Application for URBAN DESIGN COMMITTEE Review

Regenerative Stormwater Conveyance Systems (RSCS): Children's Farm Water Quality Treatment Train

Children's Farm Parking Lot

**Children's Farm
Maymont Park**

**Layout and Materials
Plan**

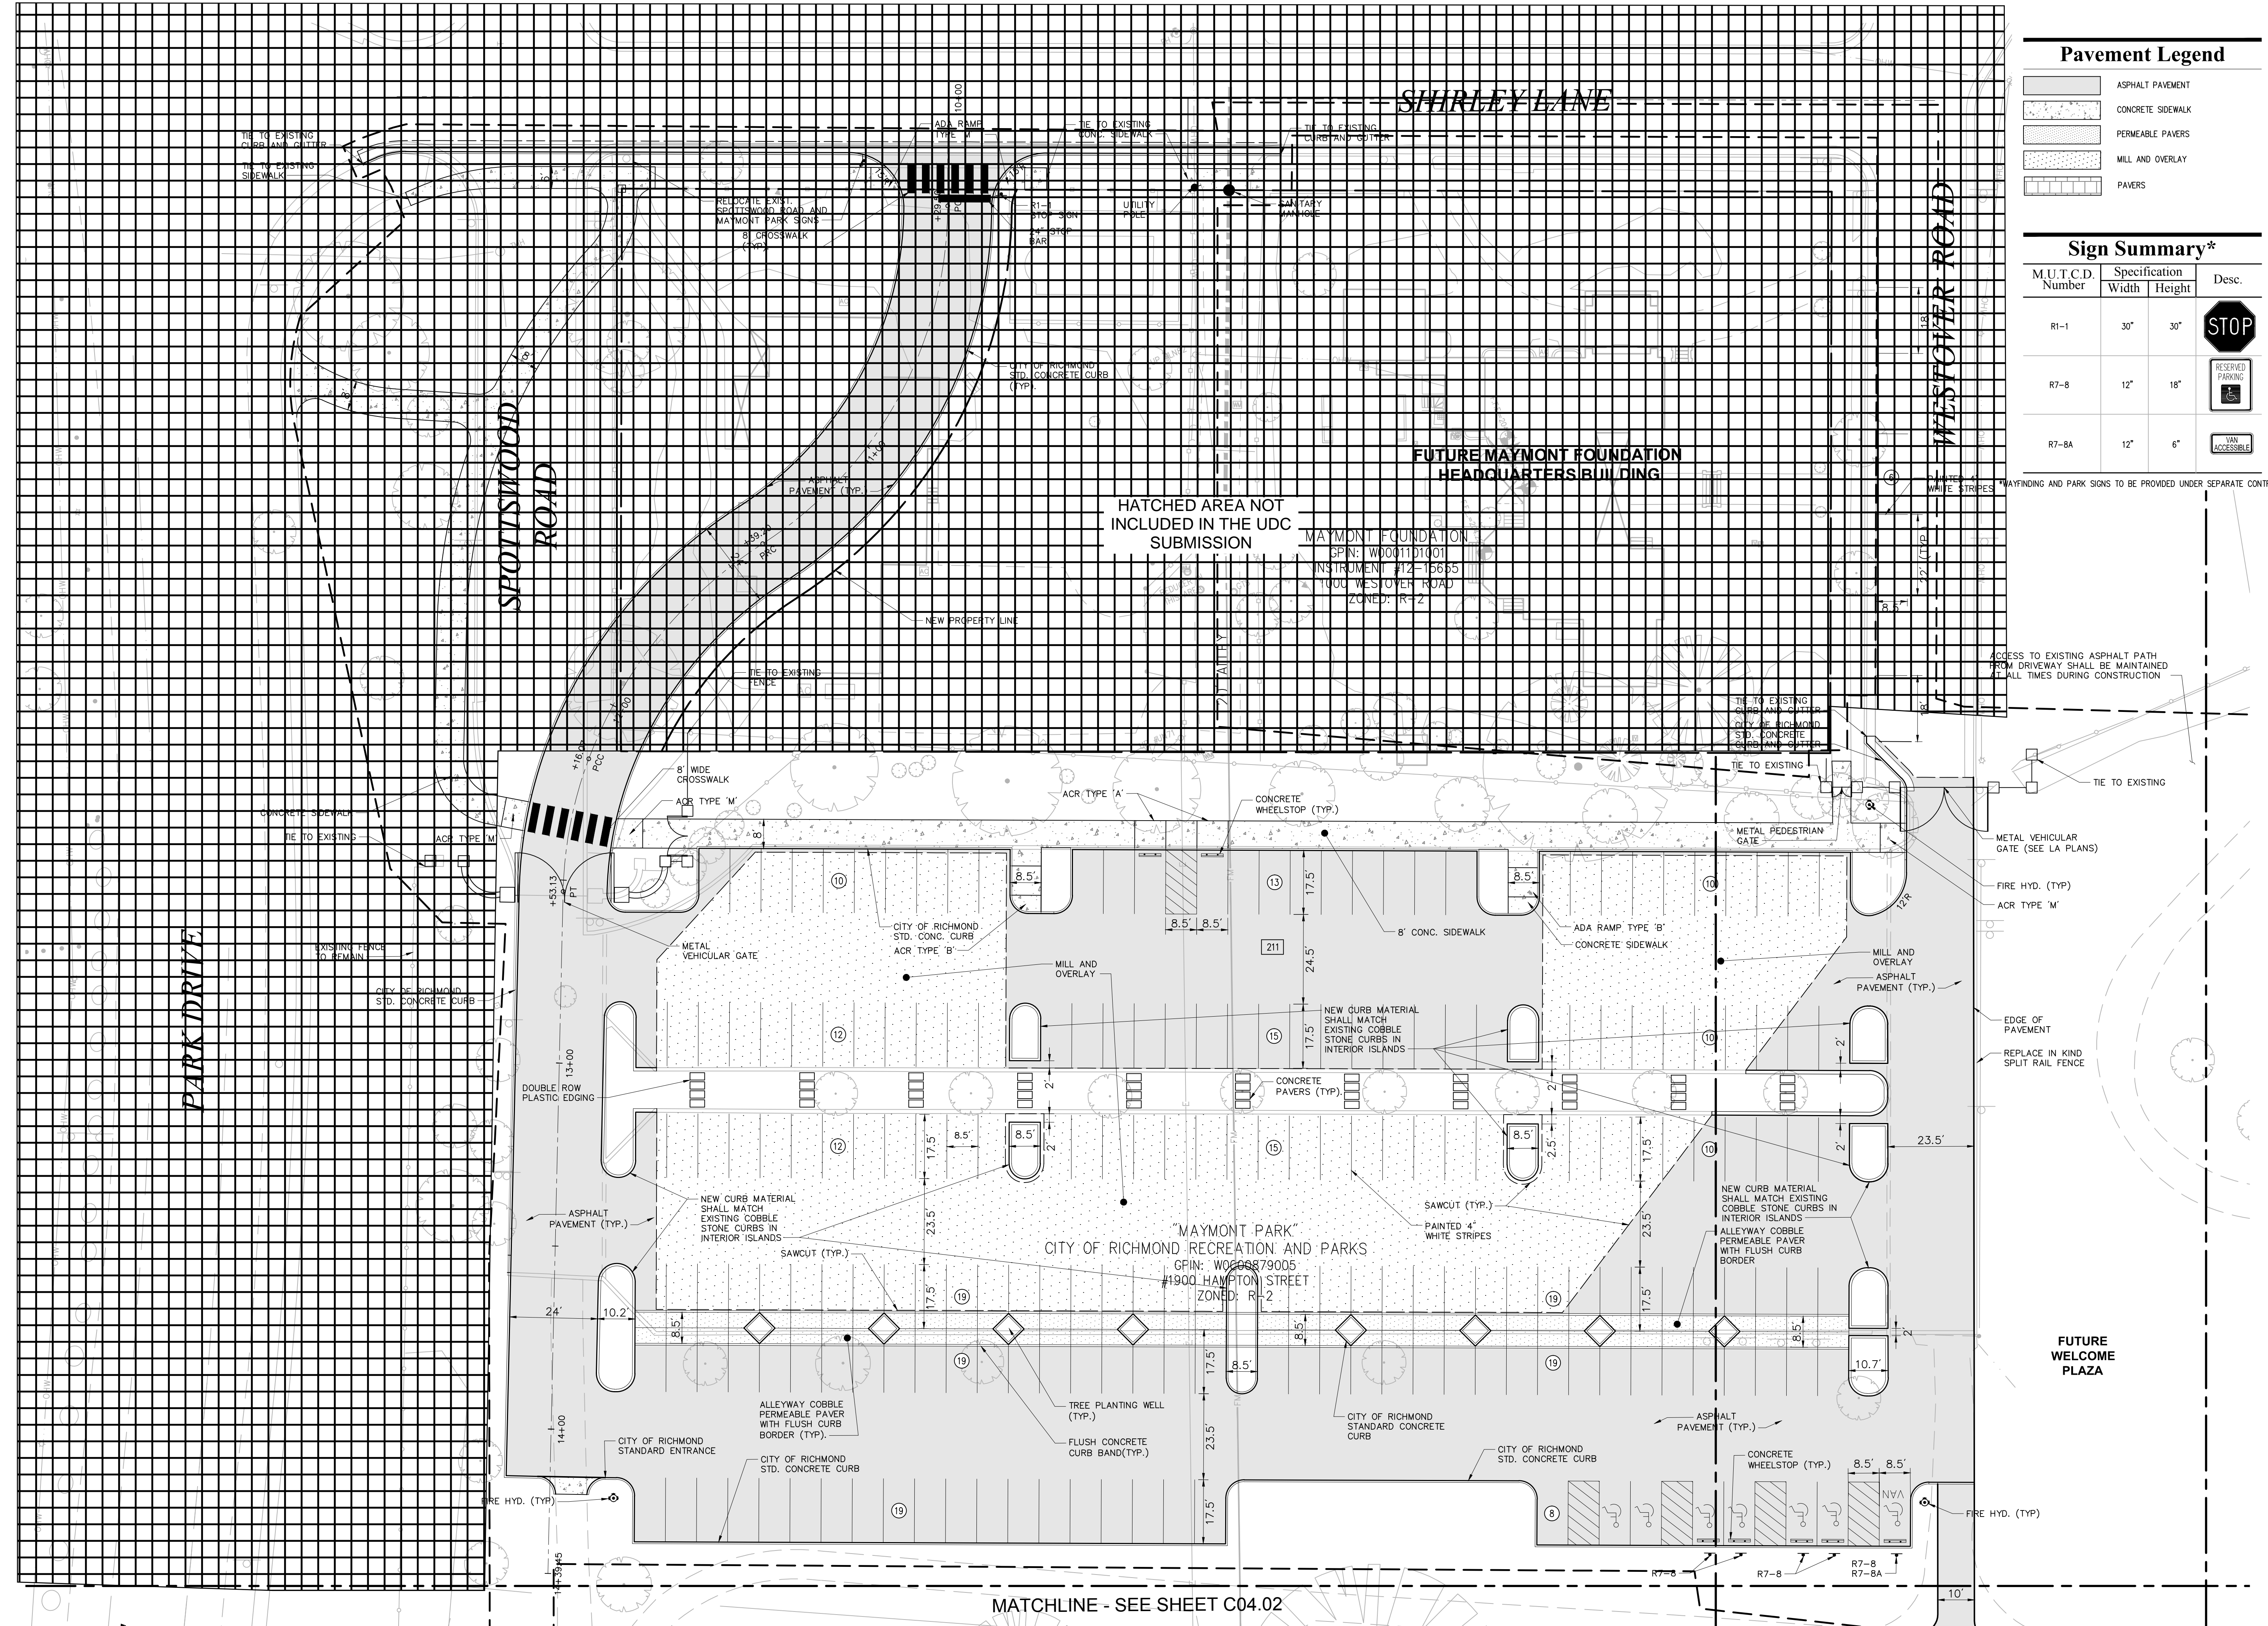
D. Pavers

The permeable paver recommended is the Alleyway Cobble by Newline Hardscapes in Doswell. Tumbled finish, granite color.

1 PLANTING PLAN - PARKING LOT
SCALE: 1" = 20'

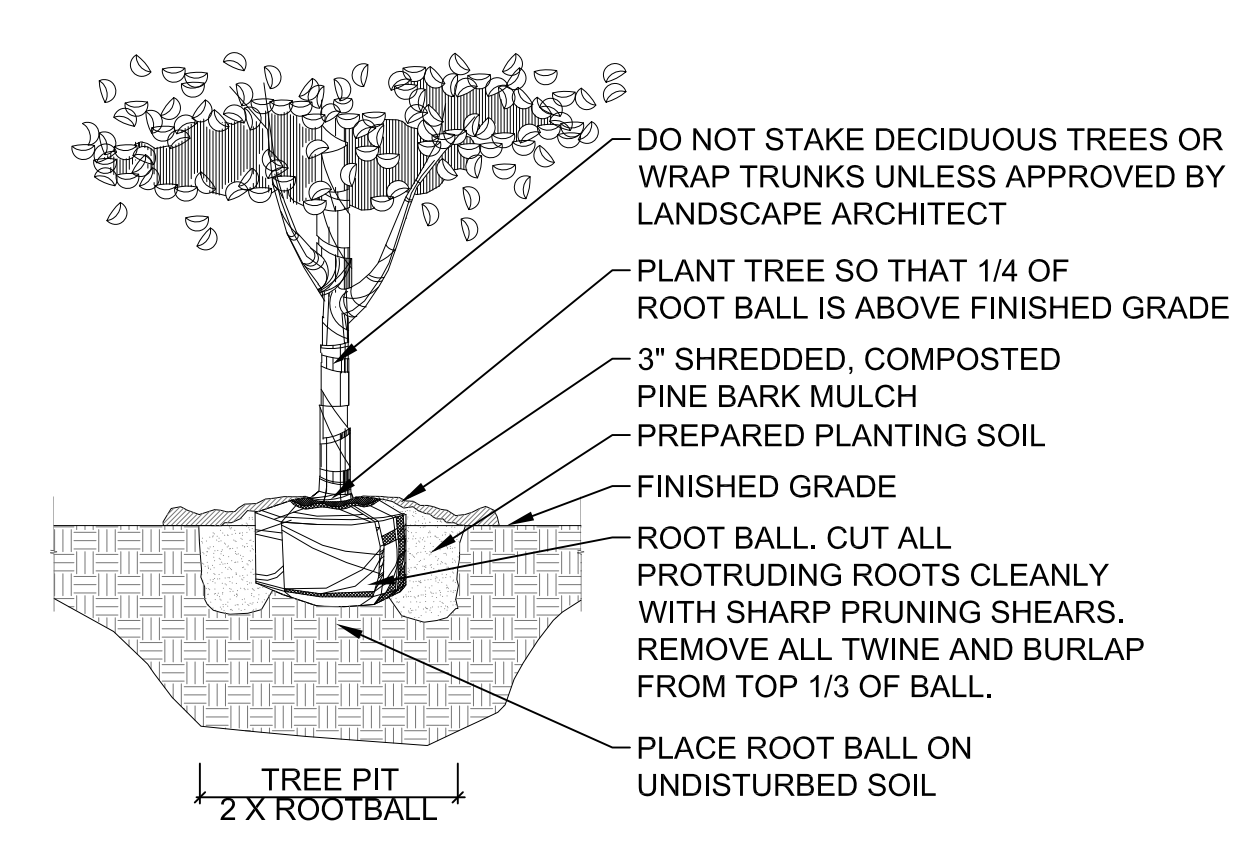
C. Planting Changes from Conceptual Submission

The existing trees are Japanese Zelkova's and are mature and have reached an age at which their health will decline. The survey done indicates that there are eight of them. This species is prone to breaking apart, dropping limbs and becoming a maintenance issue as they age and decline. They will be replaced by a hardier species that is better suited to use in difficult growing conditions. This change was recommended by both the Landscape Architect (BCWH) and Maymont's resident Horticulturalist, who added the following:

- The tree, *Zelkova serrata*, was introduced to the landscape trade as replacement for the American Elm, which were decimated by Dutch Elm Disease in the mid- 20th century.

- This tree originates from Japan and is a member of the Ulmaceae or Elm Family. With time this tree has proven to be far inferior to the American elm.

- The biggest challenge with this tree is the branch growth habit of Zelkovas, the branches grow at odd angles creating unstable branch crotches. These weak branch crotches create unsafe conditions as branches mature gaining in size with age.

- In parking lots where there is a constant presence of "targets", families, baby strollers and their cars, proactive measures need to be taken to keep everyone out of harm's way.

- Maymont's trees extend out over the parking area and are reaching the point of potential branch failure in windy and winter weather.
- At Maymont I manage a nationally known collection of mature trees so I fully understand the desire to retain our communities specimens. However, in this case, with these trees and their location this is not advisable.

- Taking action to replace the Zelkovas while renovating the CF parking lot is prudent.
